***RE: Grading and Drainage Certification Plan for the Sandia Glow Subdivision (D21/D3B),
Submitted for Release of Financial Guarantees, Engineer's Certification Stamp Dated
4/12/00.***

***RE: Revised Grading and Drainage Plan for the Sandia Glow Subdivision (D21/D3B),
Submitted for Preliminary and Final Plat Approval and Rough Grading Approval,
Engineer's Stamp Dated 1/15/99.***

RE: *Addendum to the Drainage Report for the Sandia Glow Subdivision (D21/D3B)*
Engineer's Stamp Dated 9/21/98.

DRAINAGE REPORT
FOR
THE SANDIA GLOW SUBDIVISION

SANDRA GLOW
 SUBDIVISION

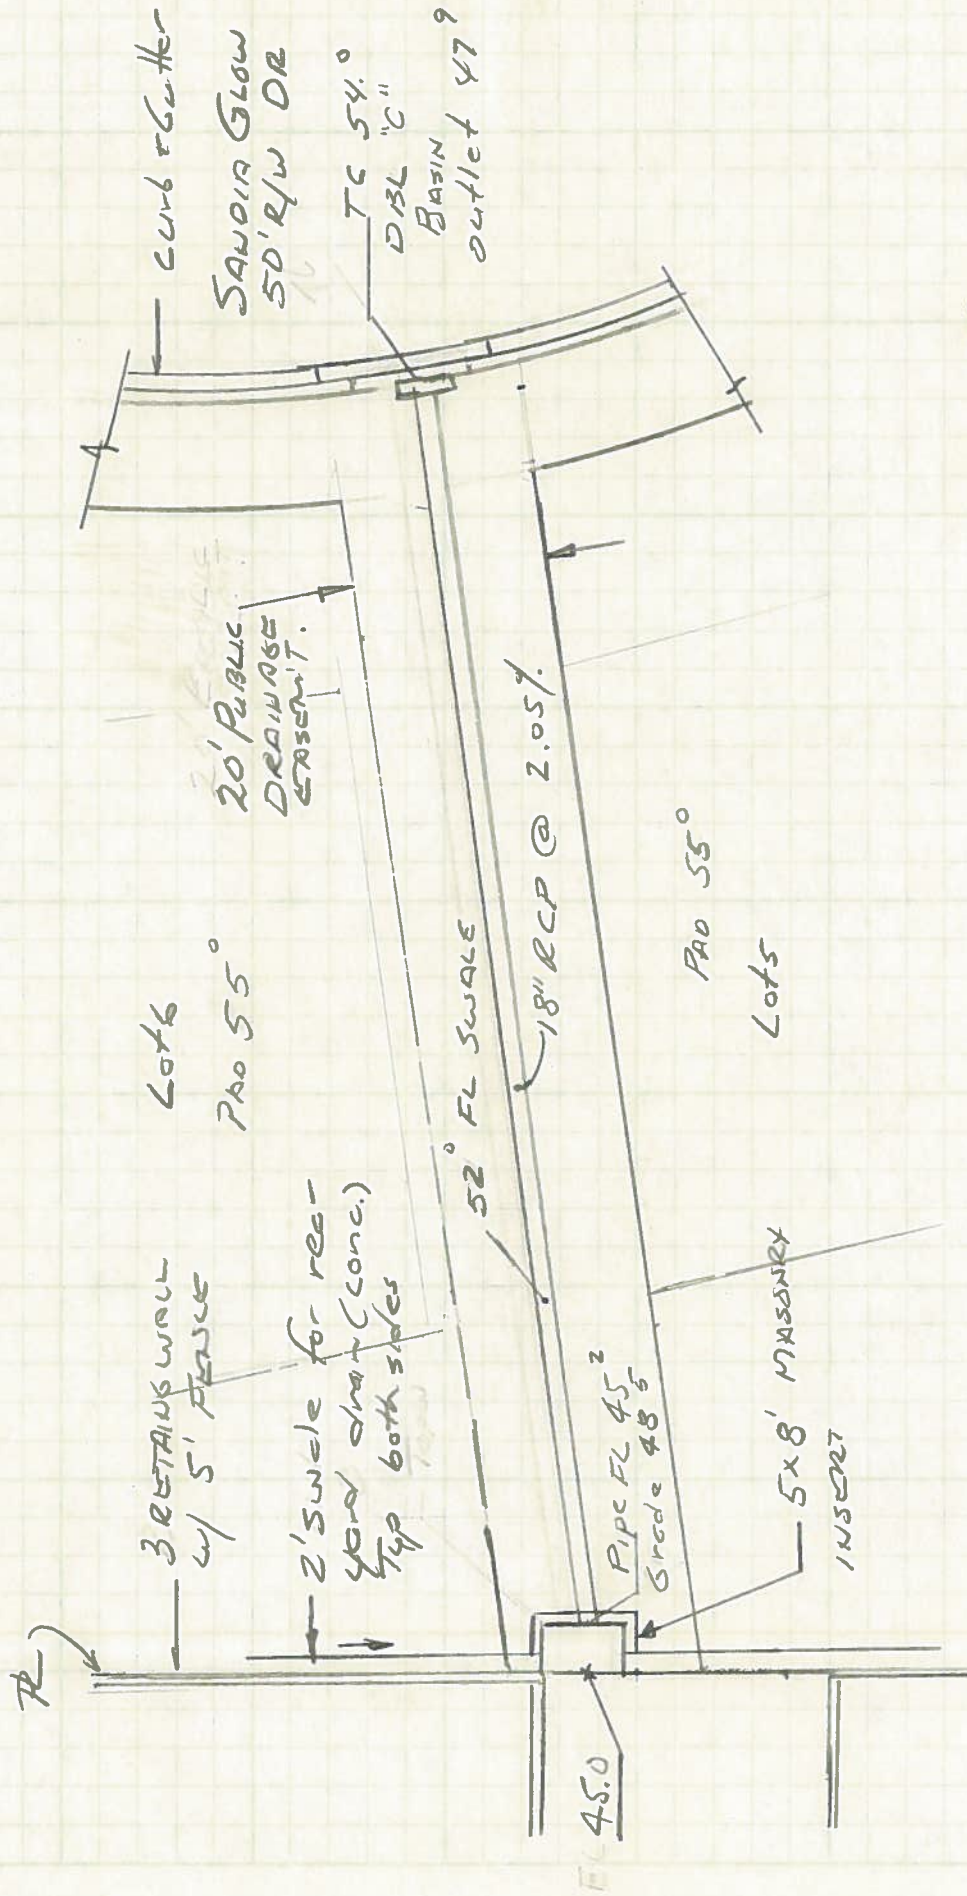
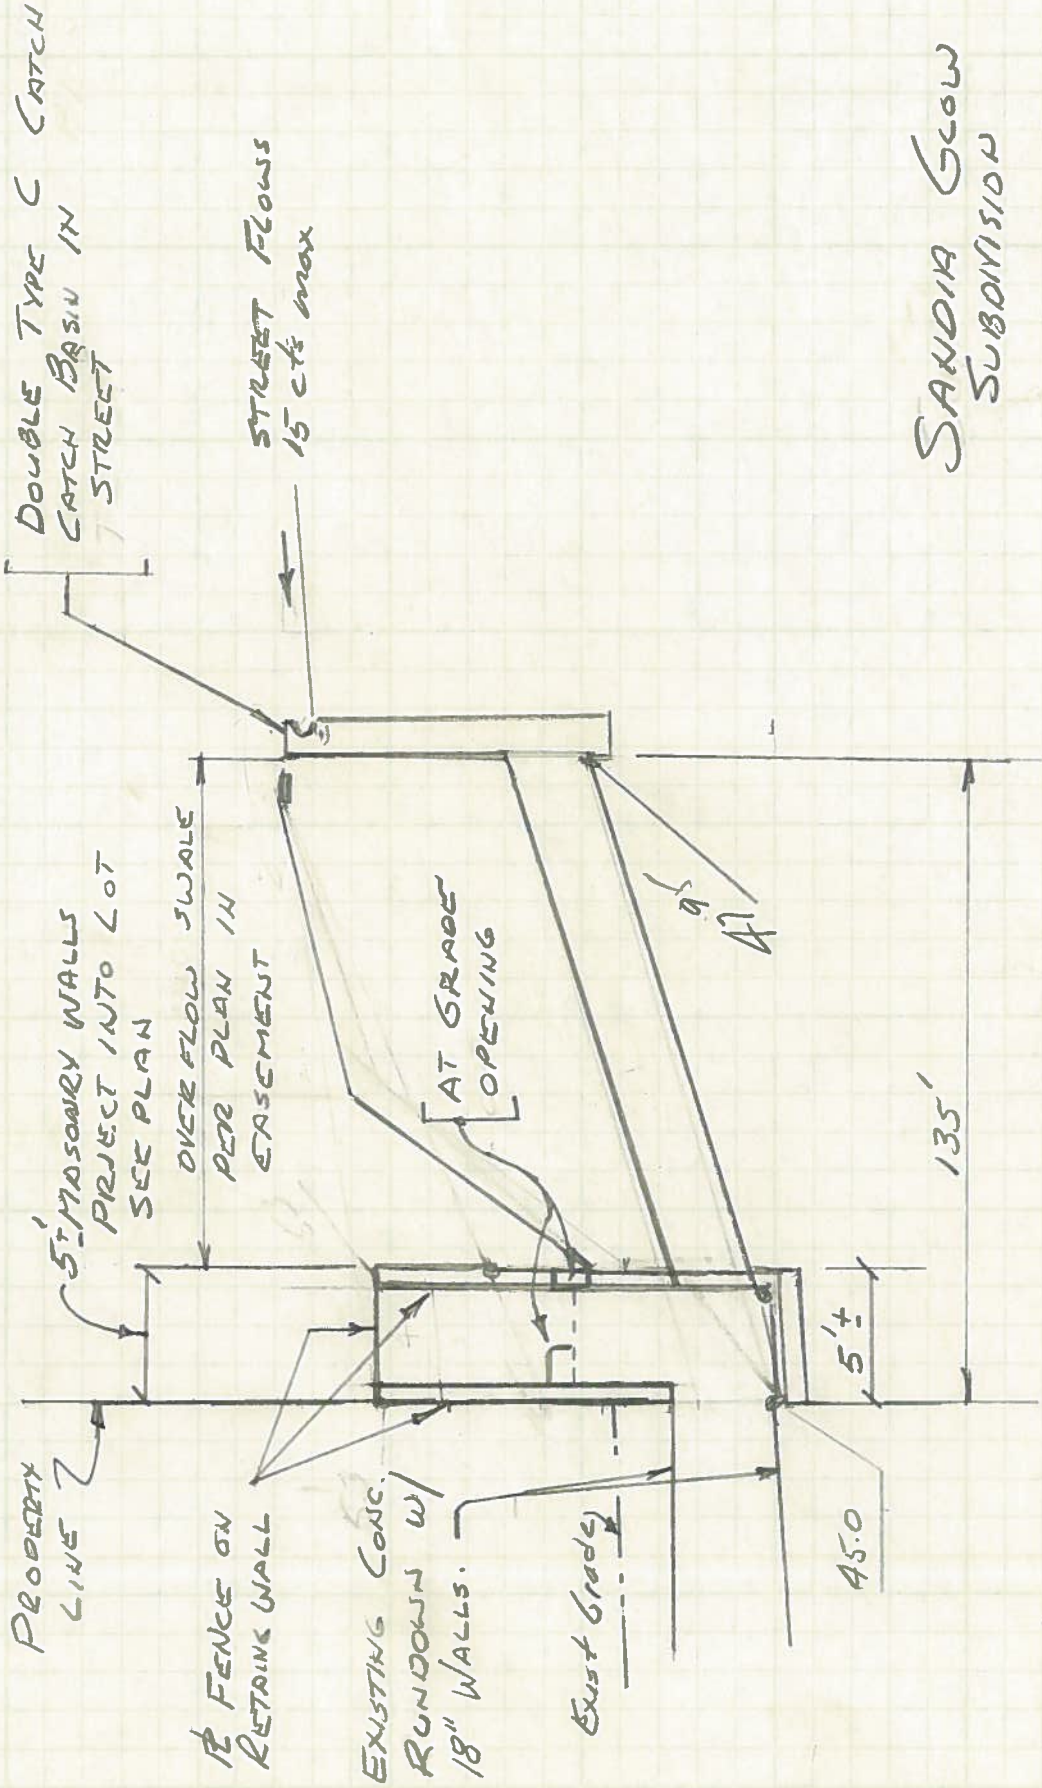
City Hydrology has no objection to your proposal to replace the 10' concrete channel with an underground storm drain pipe. It appears that a revised Infrastructure List will have to be approved by the DRB for this change. Please provide a revised grading plan showing this pipe and the proposed swale prior to DRB approval.

The submittal was unclear whether a 24" or 18" pipe is proposed. Although the 18" pipe has the capacity, using a 24" pipe is recommended for maintenance issues. City Hydrology also recommends that a Type "A" inlet be used instead of the Type "C" inlet. These details may be worked out at DRC.
